UNITED STATES PATENT AND TRADEMARK OFFICE

APPLICATION NO.	FILING DATE	FIRST NAMED INVENTOR	ATTORNEY DOCKET NO.	CONFIRMATION NO.
10/646,008	08/22/2003	Sung-Jae Moon	YOM-0048	8963
7590 Cantor Colburn LLP 55 Griffin Road South Bloomfield, CT 06002			EXAMINER NGUYEN, HOAN C	
			ART UNIT	PAPER NUMBER
			2871	
SHORTENED STATUTORY PERIOD OF RESPONSE		MAIL DATE	DELIVERY MODE	
3 MONTHS		01/30/2007	PAPER

Office Action Summary

DETAILED ACTION

FIG. 6

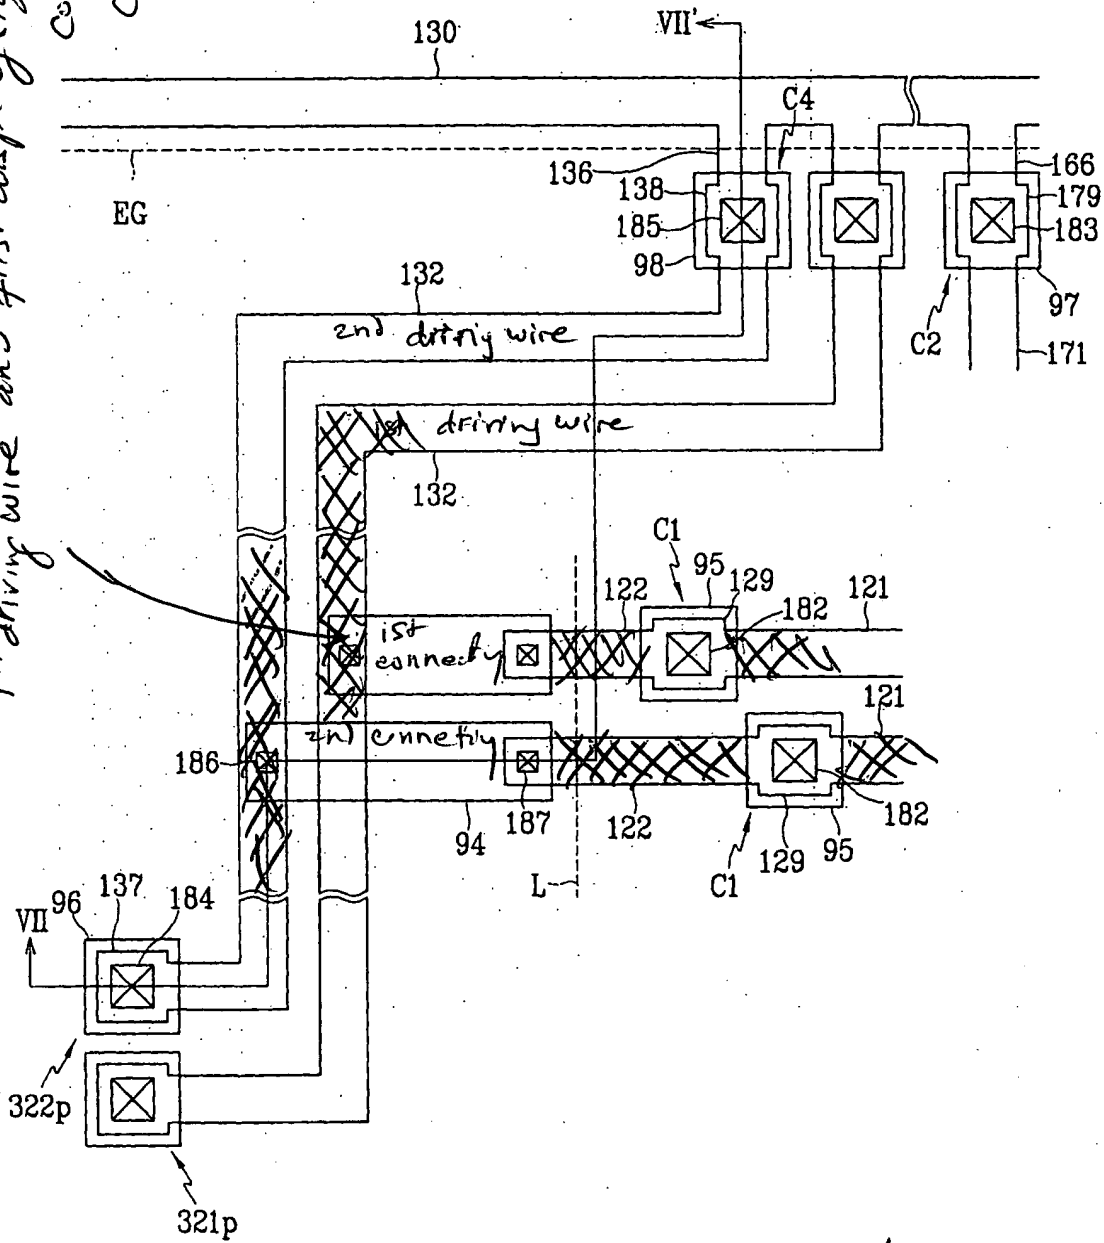
Examiner would like to thank applicants to clarify Fig. 3A and 6. However, Fig. 6 is an enlarged view of driving signal wire and shorting bar of Fig. 3A, but both two Fig. 3A and 6 still assign **the different designated numbers for the same elements**, examples:

- “driving signal wire” in Fig. 3A assigns with the designated numbers 321-322, but in Fig. 6, “driving signal wire” assigns with the designated numbers 132.
- “shorting bar” in Fig 3A assigns with the designated 320, but in Fig. 6 “shorting bar” assigns with the designated 130.

Furthermore, Fig. 3A still assigns **the same designated numbers for different elements**, examples: both the “first driving signal wire” and “second driving signal wire” assigned the same designated number 132; and both the “first connecting line” and “second connecting line” assigned the same designated number 94.

These designed numbers cause the confusion to exam the application. To avoid such confusion, please provide the Figures with assigning the different designated numbers for each of different elements. Do not assign the same number for different elements or do not assign the different numbers for the same element and be consistent the used designated numbers through all inventive drawings.

Fig. 6 shows the first connecting lines (the shorter/upper connecting member 94) disposed between the first driving wire and the first display signal wire 121, which connects to the first connecting lines (see attachment 1, shaded by blue pen).

Therefore, a part of the first display signal wire must be connects to the first connecting lines (the shorter/upper connecting member 94). The first connecting line (the shorter/upper connecting member 94) cannot be in between the first driving wire (shaded by blue pen) and the first display signal wire (shaded by red pen), which does not connect to the first connecting line.

Fig. 6 shows the second connecting line (the longer/lower connecting member 94) disposed between the second driving signal wire and the first display signal wire 121, which connects to the second connecting line (see attachment 1, shaded by red color pen). Therefore, another part of the first display signal wire must be connects to the second connecting line. The second connecting line (the longer/lower connecting member 94) cannot be in between the second driving wire (shaded by red pen) and the first display signal wire (shaded by blue pen), which does not connect to the first connecting line.

1st connecting line disposed between
1st driving wire and first display signal wire, which
connects to 1st
connecting line
